Figure 1. Inner Primary Vent Tube

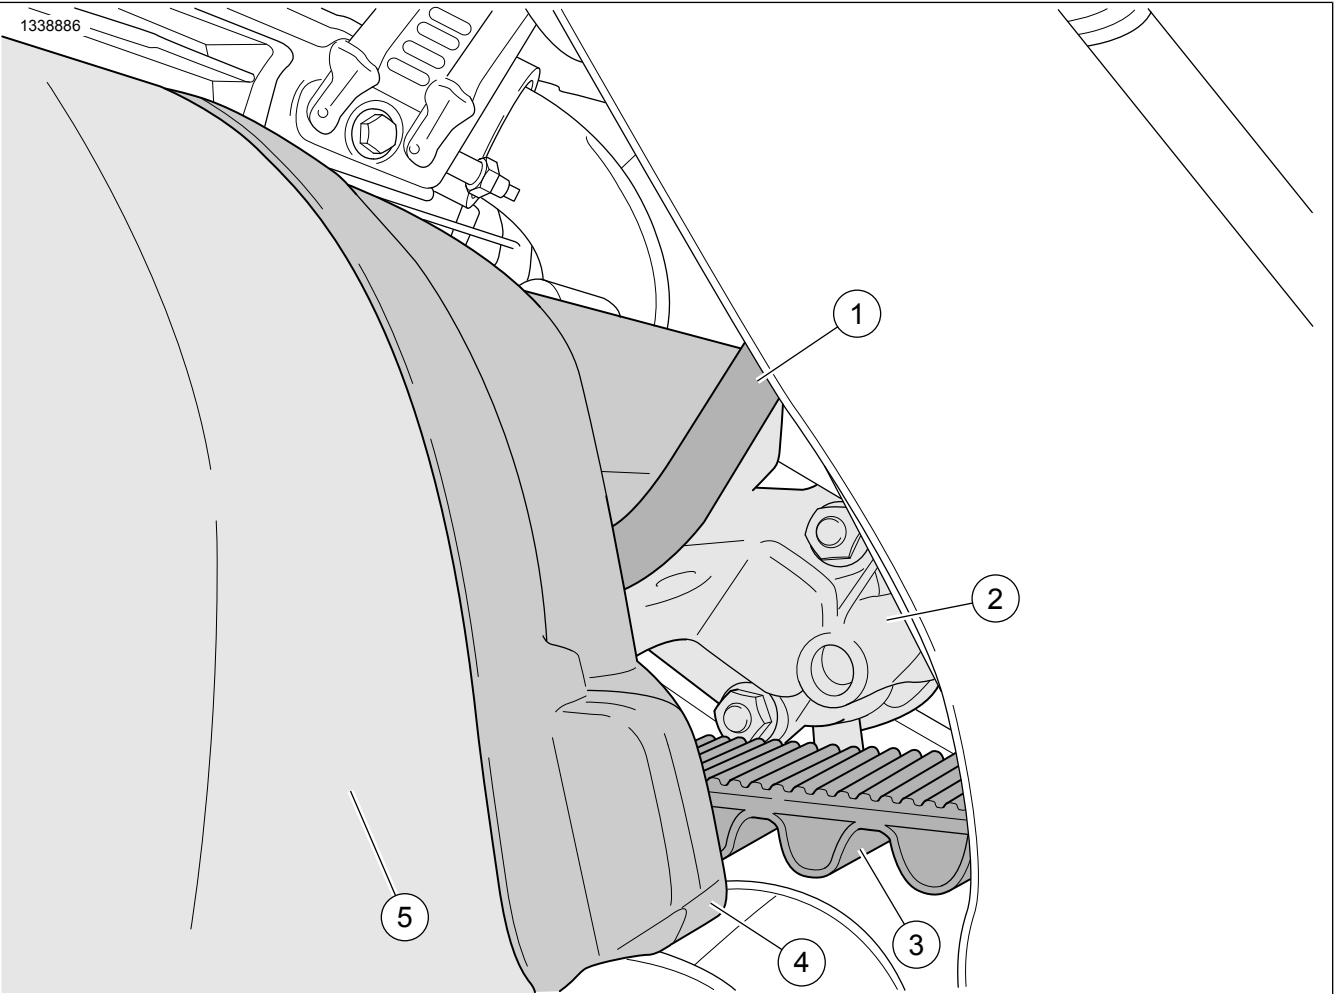
1. See Figure 1. Check for vent tube (1).
 - a. If vent tube is present **STOP**, this service procedure has already been performed.
 - b. If vent tube is not present, go to 2.
2. Install Inner Primary Vent Service Kit (Part No. 26500027) per the instructions included in the kit.
3. **2017 - 2018 Models: STOP** kit installation is completed.
4. **2019 Models:** Remove oil deflector.
 - a. Remove transmission inner side cover. See the service manual.
 - b. Remove mainshaft transmission oil deflector (Part No. 36300026).
 - c. Install transmission side covers. See service manual.
